PRODUCT / PROCESS CHANGE NOTIFICATION

1.1 Company		STMicroelectronics International N.V
1.2 PCN No.		ADG/17/10493
1.3 Title of PCN		PSSO-16 Deep Down Set (VIPOWER M0L7): Lead frame Additional Supplier (SDI) introduction for Shenzhen Assembly Plant
1.4 Product Category		see list
1.5 Issue date		2017-11-13

Leadframe Comparison (P/N 5FT29152)

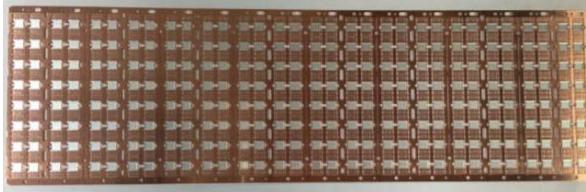
Please be informed that a second source supplier for lead frame (SDI) has been qualified for VIPOWER M0L7 housed in PSSO-16 Deep Down Set package version beside current SHM (Sumitomo)

SHM Etched

SDI Stamped
